SUBJECT: DUANE ARNOLD ENERGY CENTER AND MONTICELLO NUCLEAR
GENERATING PLANT RE: REQUEST FOR AUTHORIZATION TO UTILIZE
CODE CASE N-613-1 (TAC NOS. MC2374 AND MC2375)

SAFETY EVALUATION BY THE OFFICE OF NUCLEAR REACTOR REGULATION

REQUEST FOR RELIEF, 10-YEAR INSERVICE INSPECTION INTERVAL

FIG. 2 NOZZLE IN SHELL OR HEAD
(Examination Zones in Flange Type Nozzles Joined by Full Penetration Butt Welds)

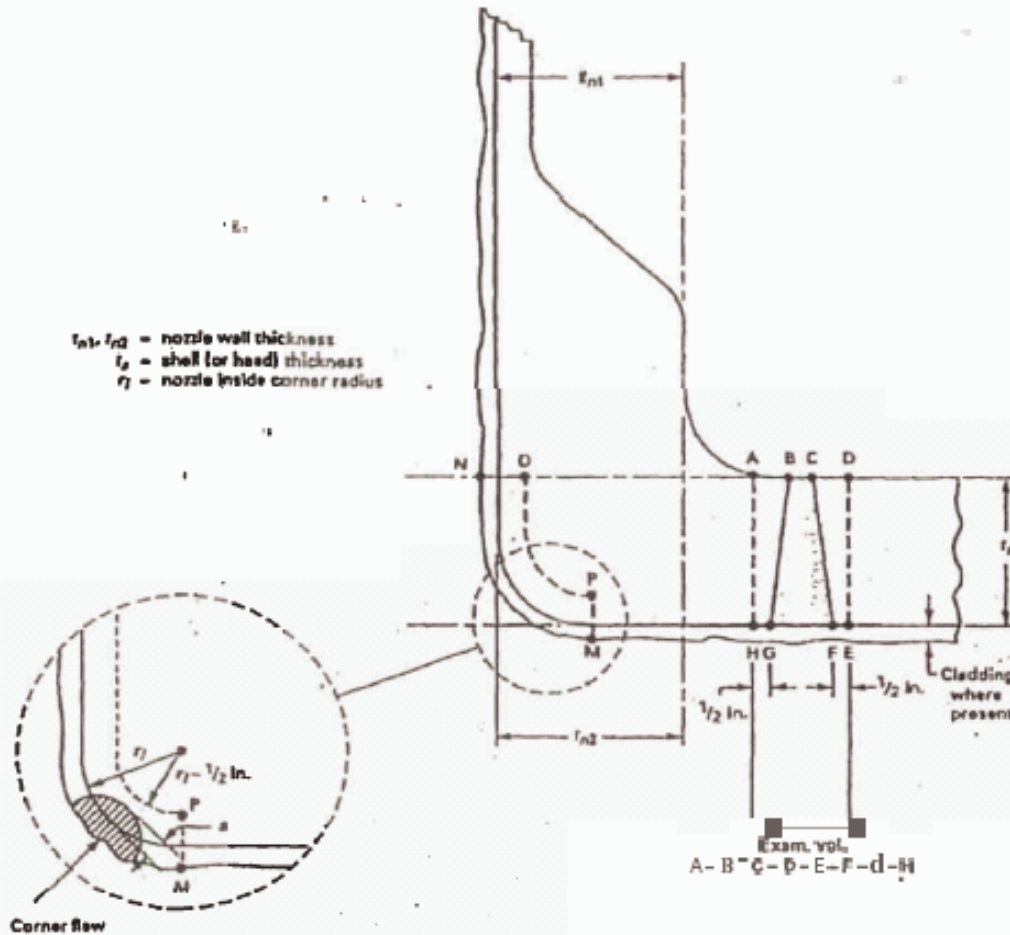
NMC proposes to use a reduced examination volume according to ASME Code Case N-613-1, which extends to one-half ($1/2$) inch from the widest part of the weld, in lieu of the examination volume requirements of ASME Code Section XI, Figure IWB-2500-7(b), which specify an examination volume extending to a distance of $t_s/2$ from the widest part of the weld.

On June 15, 2004, the staff issued a request for additional information (RAI) to support the request for relief. In this letter, the staff requested that the licensee provide a supplemental diagram showing the proposed examination volume. In their RAI response dated July 21, 2004, the licensee provided a sketch and a list of all nozzle-to-vessel welds within the scope of this relief request and are included in Attachment 1 and Attachment 2, respectively.

The licensee has requested relief from the examination volume requirements specified in Table IWB-2500-1 of the ASME Code Section XI, pertaining to full penetration nozzles in the RPV. NMC proposed to use a reduced examination volume, extending to one-half ($\frac{1}{2}$) inch from each side of the widest part of the nozzle-to-vessel weld in lieu of an examination volume extending to a distance equal to one-half ($\frac{1}{2}$) the through-wall thickness from each side of the widest part of the nozzle-to-vessel weld.

The licensee provided supplemental information showing the specific configuration of the nozzle-to-vessel welds and the revised examination volume, as well as a listing of all welds included within the scope of this relief request. All of the welds for which relief is requested have a configuration as shown in Figure 2 of the ASME Code Case N-613-1. The specific revised examination volume is defined as region A-B-C-D-E-F-G-H. All other aspects of the examination volumes for RPV nozzle-to-vessel welds remain unchanged by the licensee's request.

Based on the above, the staff finds that the areas to be excluded from examination by the relief request have been found to be free of unacceptable flaws by previous examinations performed during inservice inspection and fabrication. The staff has determined that the initiation of flaws in these regions is highly unlikely due to the lower weld-induced stresses. Therefore, the proposed alternative to reduce the UT examination volume to one-half ($\frac{1}{2}$) inch from the widest part of the nozzle-to-vessel weld on each side of the weld crown will provide an acceptable level of quality and safety as required in 10 CFR 50.55a(a)(3)(i).

The staff has reviewed the licensee's submittal and concludes that the proposed alternative will provide an acceptable level of quality and safety. Therefore, pursuant to 10 CFR 50.55a(a)(3)(i), the staff authorizes the use of ASME Code Case N-613-1 for the remainder of the third 10-Year Interval of the Inservice Inspection Program at DAEC, and for the remainder of the fourth 10-Year Interval of the Inservice Inspection Program at MNGP.
